UNITED STATES
NUCLEAR REGULATORY COMMISSION
WASHINGTON, D. C. 20555

SUBJECT: FORT ST. VRAIN - PLANT PROTECTION SYSTEM TRIP SETPOINTS

We are reviewing your submittal dated June 21, 1985 proposing Technical Specification changes for Fort St. Vrain. The proposed changes are in response to concerns that the trip setpoints specified in the present Technical Specifications are non-conservative. The present setpoints reflect the value of the measured parameters at which the safety analysis assumed that safety actions would be initiated. These values do not include consideration of instrumentation uncertainties. This could result in safety actions being initiated at measured parameter values which are less conservative than were assumed in the safety analyses.

Fort St Vrain Nuclear Generating Station

FIGURE 3.32

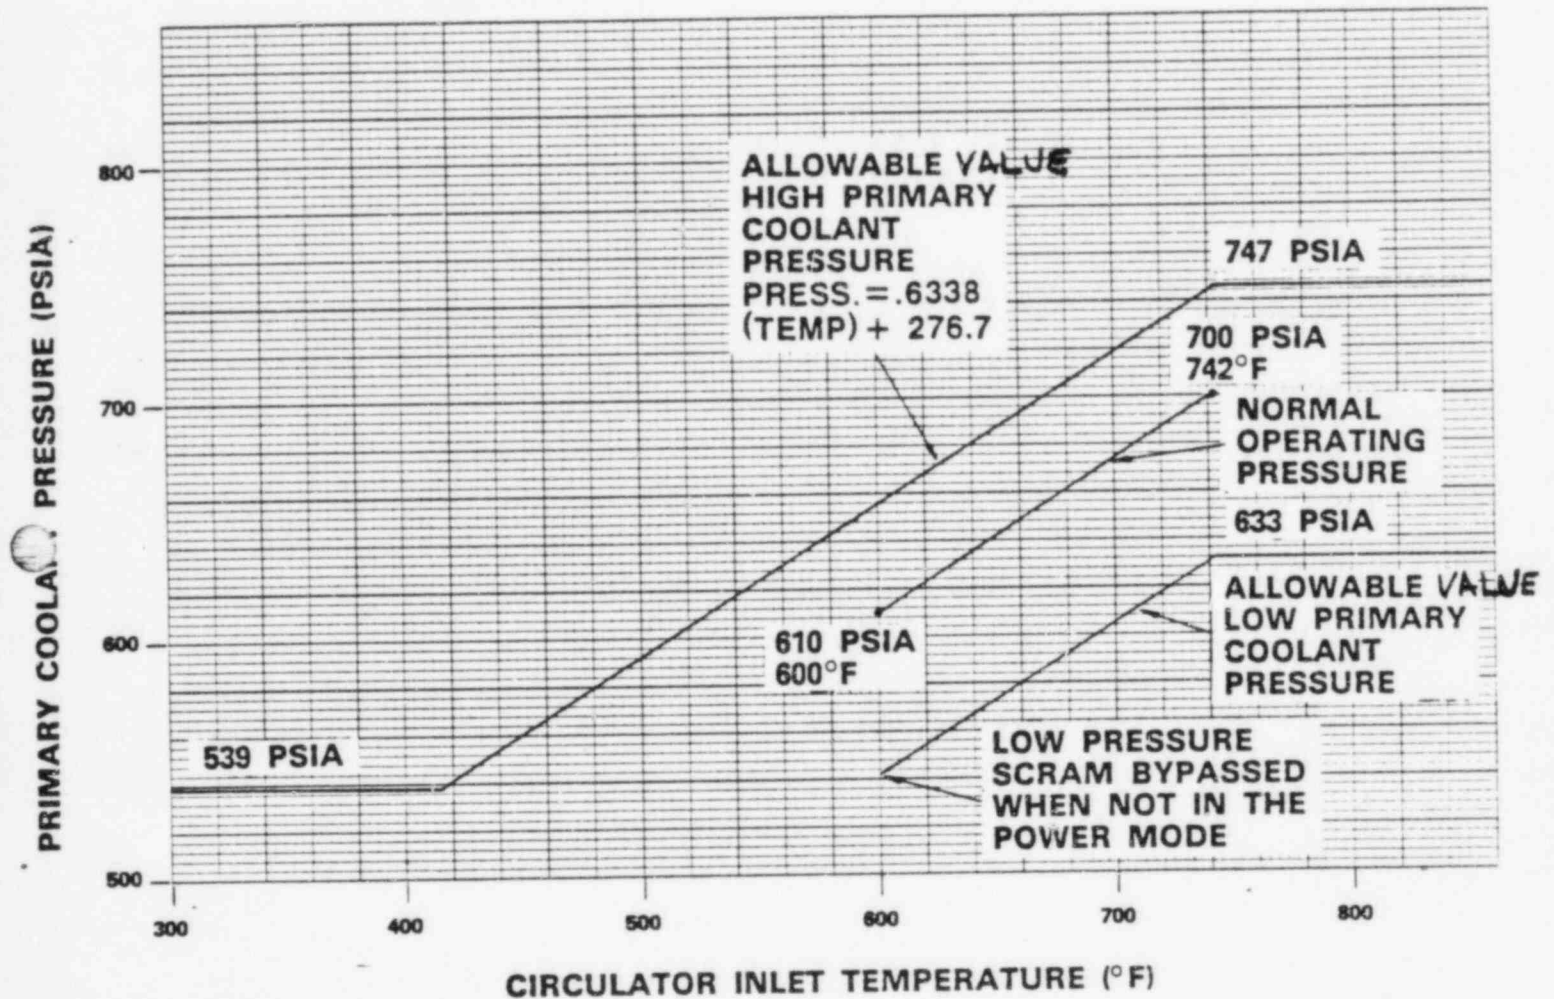
7. (p 3.3-6) The upper and lower curves should be identified as the ALLOWABLE VALUES for the respective channel.
8. (p 4.0-2) Specification 4.0.1 and 4.0.2 do not establish any specific requirements and should be deleted. Information such as this should be included in a Bases section if it is desired to retain it.
9. LCO 4.4.1 should be revised to: ...the values shown in Part 1 of Tables 4.4-1 through 4.4-5. Consistent word usage: shown rather than displayed.
10. The second part of the Action for LCO 4.4.1 should be deleted. The intent of Specification 4.0.6 is to preclude mode changes without reliance on Action requirements. As noted in 4.0.6, exceptions are stated in the
